Tom Renzo proposed the following features for Cave 2. In both images, you are looking south toward Cave 1

SECTION C NEW CAVE, LKF SOUTH
 $1/4" = 1'-0"$

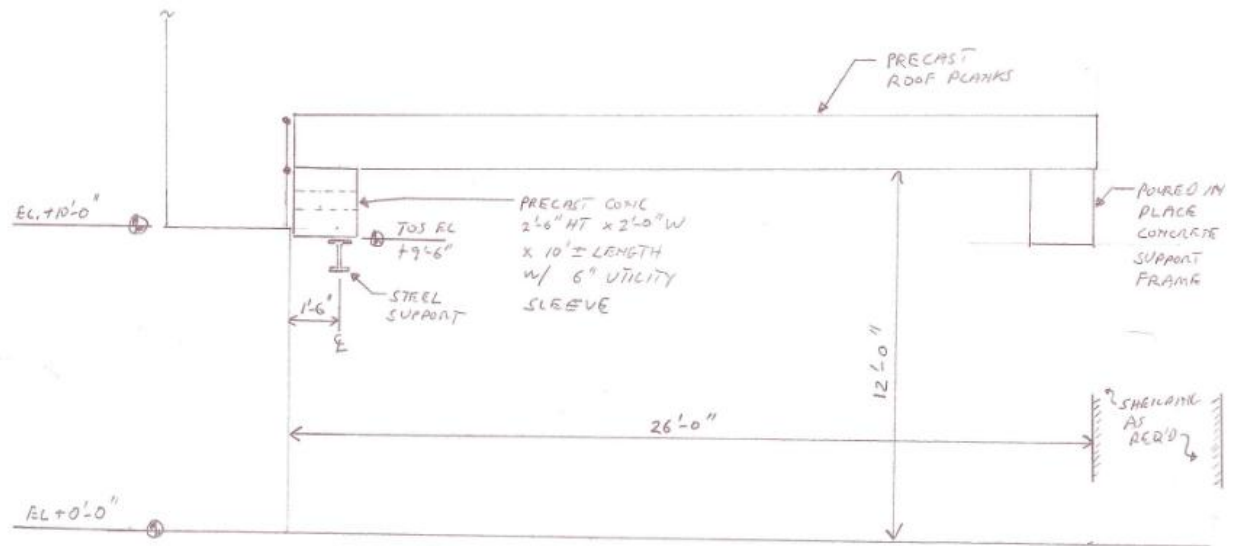
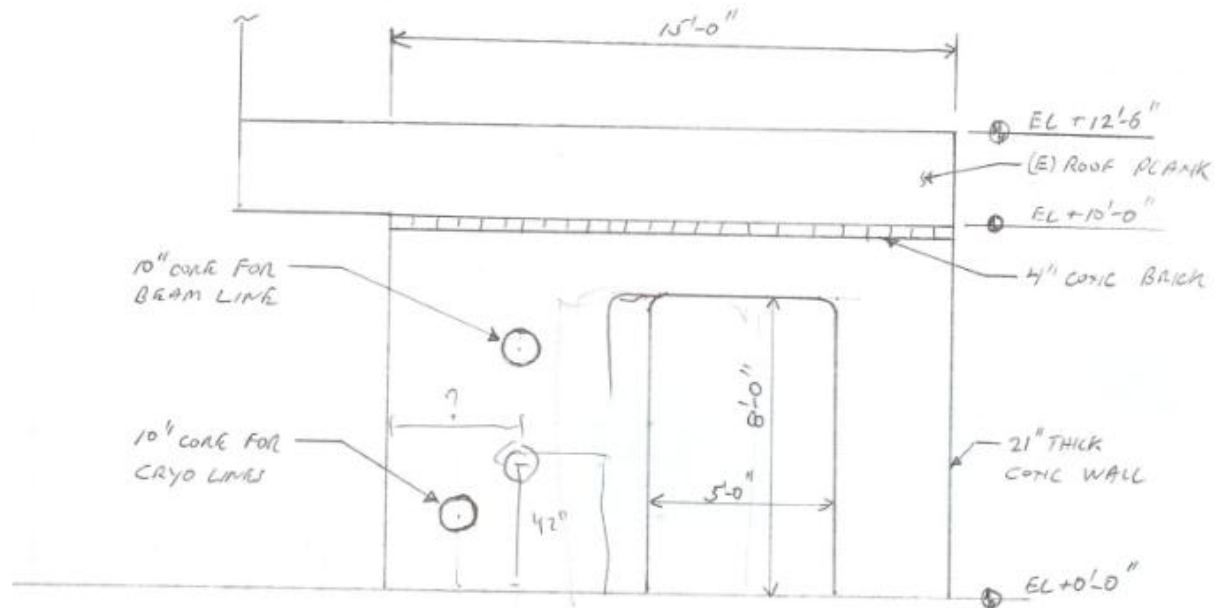
- 1) How long will Cave 2 be? Answer: as long as possible. The outside wall of the North side of Cave 2 should line up with the existing yellow walkway. And per Rad Con's calculations, we assume the North wall is 6 ft thick.

- 2) Tom suggested an opening between the two caves 5 ft wide and 8 ft tall. We suggested 6 ft wide. But a wider opening might diminish structural integrity of this wall. Either way, we should be able to move the 1/4CM through this opening.

- 3) How far OFF the wall does HDIce live? Our plans today imagine the beamline approximately 50 inches displaced from the East wall. We think HDIce is approximately 4 ft wide, and centered on the beamline, so HDIce would extend 2 ft on either side of beamline. Consequently, this seems compatible with our 50 inch beamline displacement from wall. We will likely want to coordinate the placement of steel I-beams that will hold up the ceiling. I-beams every 18 to 24 inches.

- 4) How many core holes do we need in the wall between caves? One for beamline, and one for cryo plumbing. Do we need holes for LCW and our beamline cables? 10 inches diameter ok?

- 5) Roots blower inside Cave1 or outside? Pros and cons to both. Today, we are planning on leaving blower inside Cave1, and dealing with noise and heat.
